REPORT OF USATECOM PROJECT NO 7D-3255-01 SERVICE TEST
OF CONTROLLER, DIFFERENTIAL PRESSURE, PIPELINE
PUMP UNIT (DA PROJECT NO 8M53-03-001-06)

SUBJECT: Report of USATECOM Project No. 7D-3255-01, Service
Test of Controller, Differential Pressure, Pipeline Pump
Unit (DA Project No. 8M53-03-001-06)

SUMMARY SHEET

REAR OF TEST ITEM

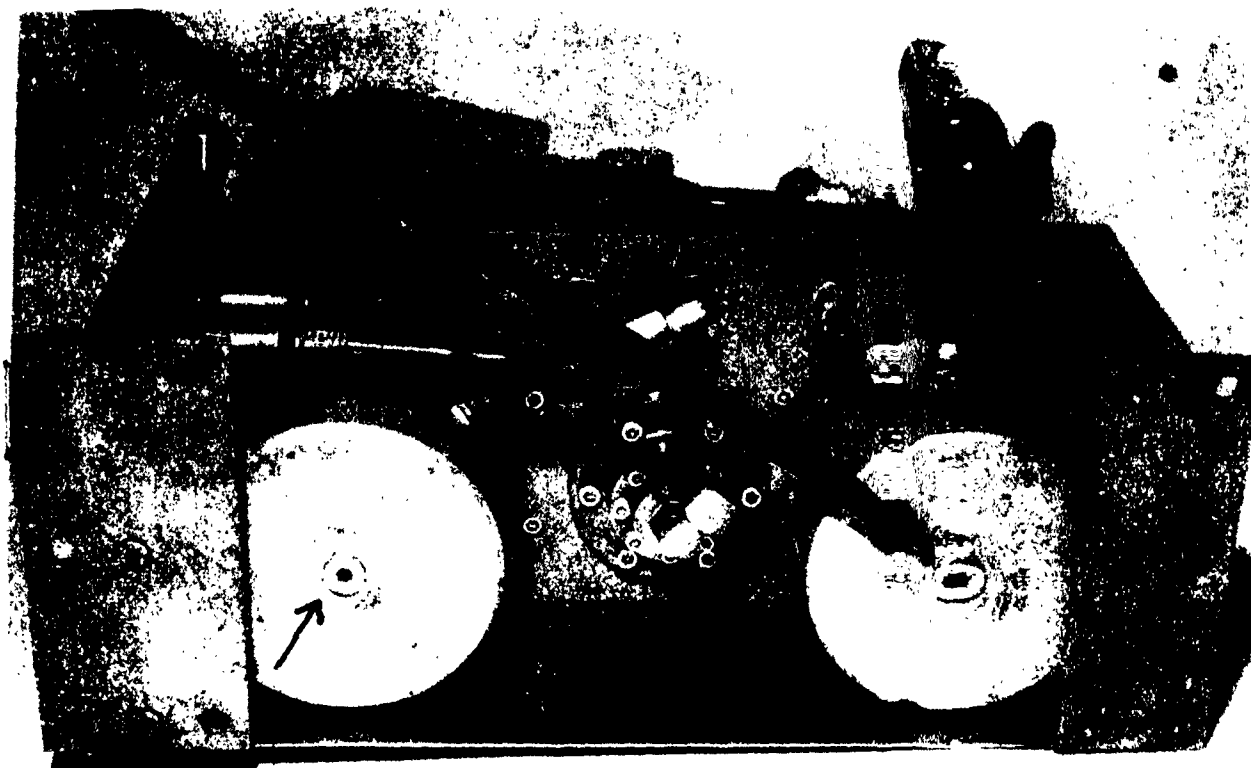
3. The spring-loaded check valves on the control units do not allow the fluid to flow freely from the reservoir.

| 11. The plug valve is easily broken off at the base during shipment of the control unit. | Brace the reservoir and plug valve assembly to the main body of the control unit or provide for removal during shipment. | See page C.2, annex C. |

1. PLUG VALVE. ARROW INDICATES POINT OF BREAKAGE.
2. SPRING-LOADED CHECK VALVES THAT OBSTRUCT FREE FLOW FROM RESERVOIR.

Replace the present check valves with non-spring-loaded type.

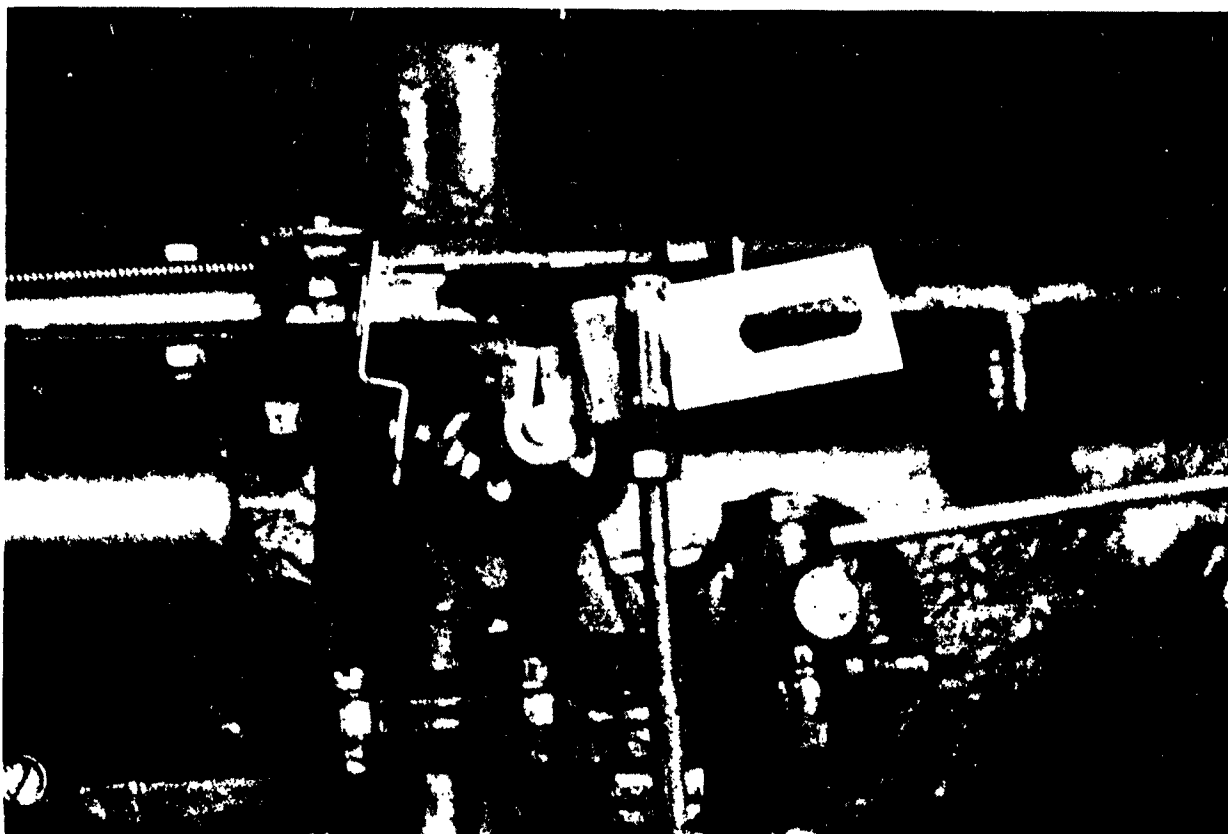
5. The springs and housing of the low and high pressure cutoff adjustment screws became rusted making adjustment difficult.

| 7. The existing fast-idle stop is too long and causes the engine to idle at approximately 1,400 rpm during warmup period. | Shorten the fast-idle stop to allow the engine to idle at approximately 900 rpm. | See item K, page C.7, annex C. |

Make the springs and housings from a rust resistant material.

CARBURETOR CONNECTING ARM FABRICATED LOCALLY

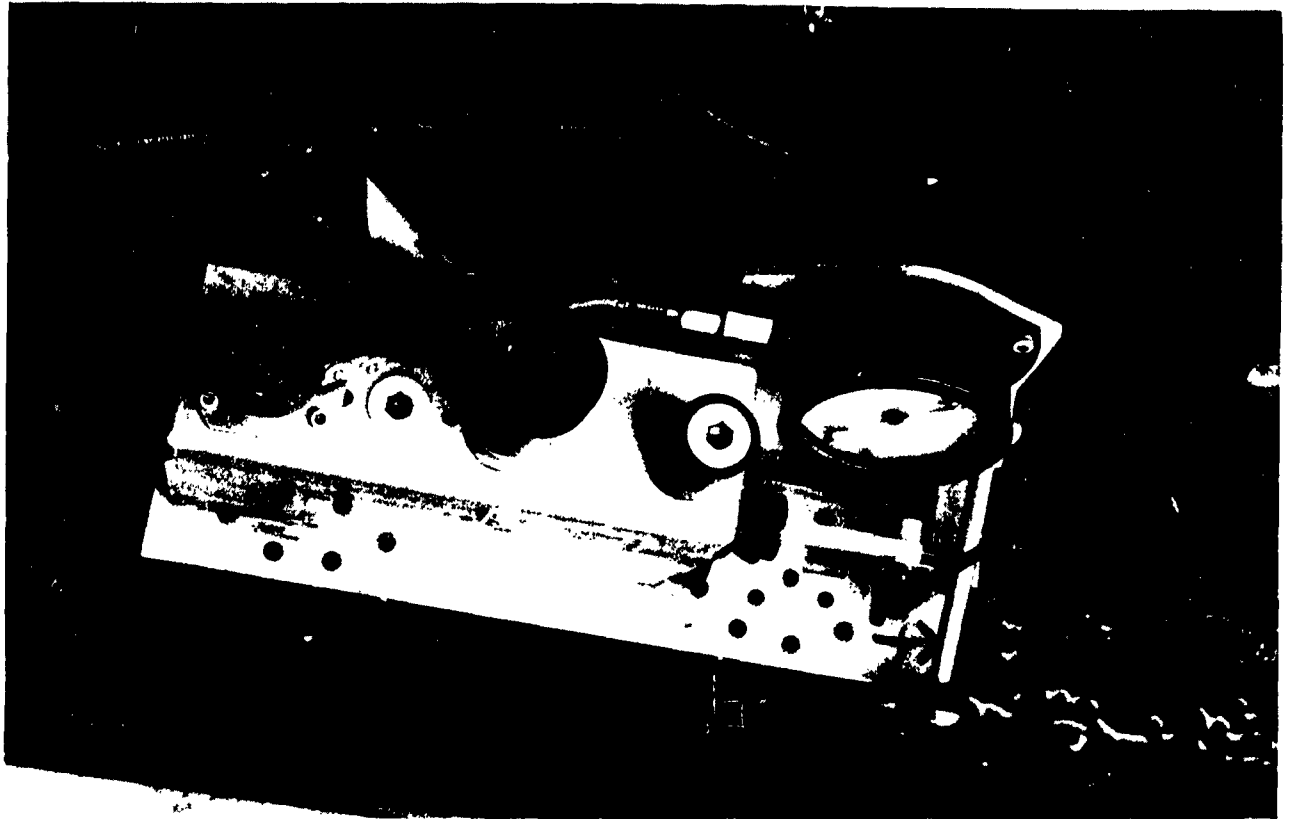
c. The test items were received in Japan minus the controller linkage connecting the unit with the engine carburetor. A connecting arm was fabricated locally (photograph C.8, annex C).

TEST ITEM MOUNTED ON PUMP. NOTE EXCESSIVE LENGTH OF
HANDLE. (ARROW)

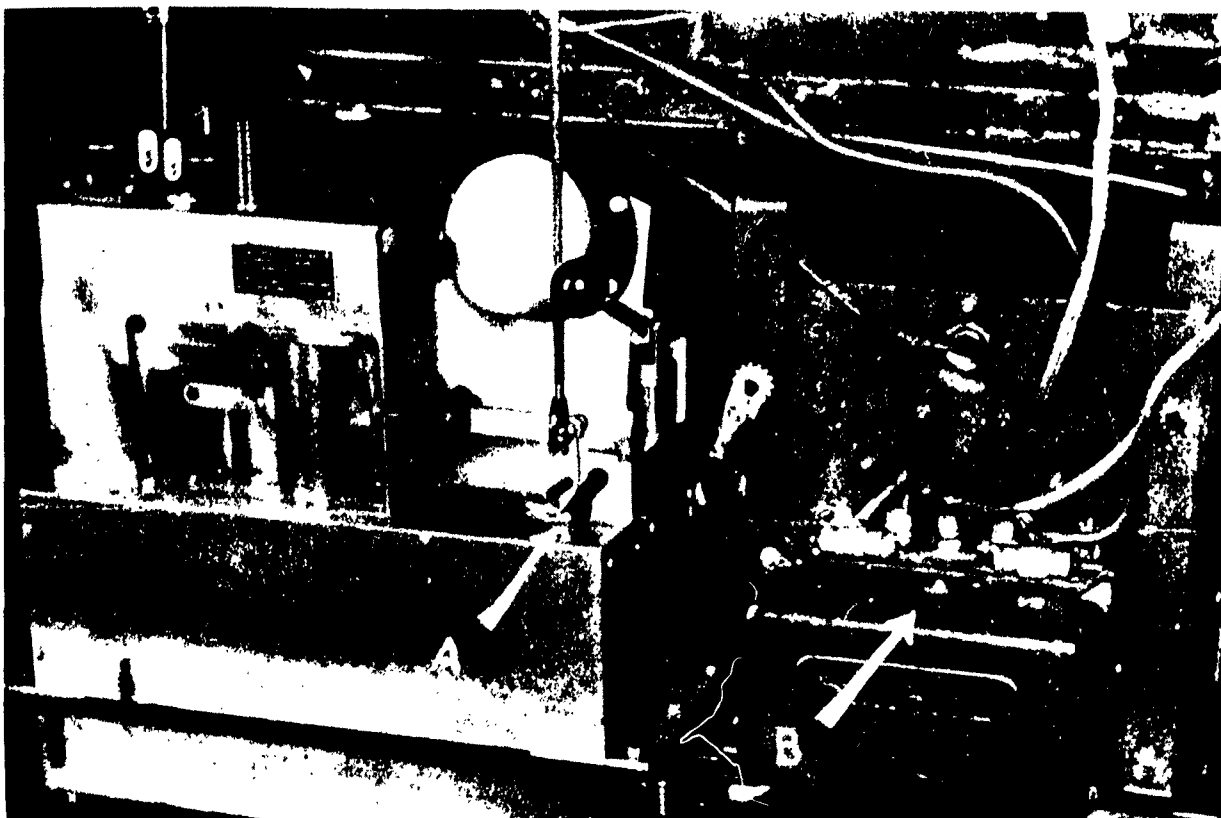
| 8. The hydraulic hand pump handle is too long and hits the side panel of engine. | Shorten the handle so as not to extend beyond the side of the control unit. | See page C.10, annex C. |

MOUNTING OF TEST ITEM ON PEERLESS MANUFACTURING COMPANY
PUMP NECESSITATED MOVING VOLTAGE REGULATOR FROM POINT "A"
TO POINT "B".

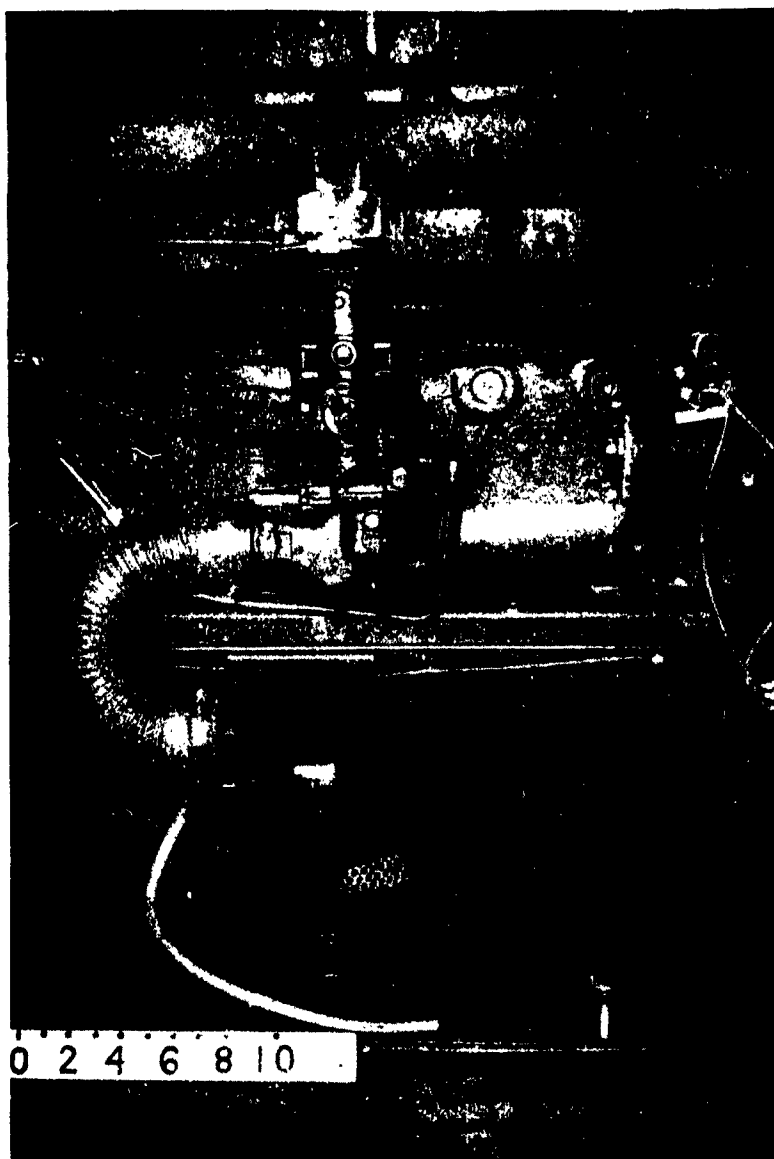
1. PURPOSE. To determine the compatibility of the test item with related equipment.
2. METHOD. The test items were mounted on pumps manufactured by Peerless Pump Company and Consolidated Manufacturing Company, both standard items in the supply system. Difficulties encountered and modifications required were noted.
3. RESULTS.
 - a. On the pump units fabricated by Peerless Pump Company, the voltage regulator and the reverse current overload switch had to be relocated to allow installation of the test item. (See page C.11, annex C.)
 - b. On the pump units fabricated by Consolidated Manufacturing Company the oil bath type air cleaner had to be relocated to allow installation of the control unit. (See page C.12, annex C.)
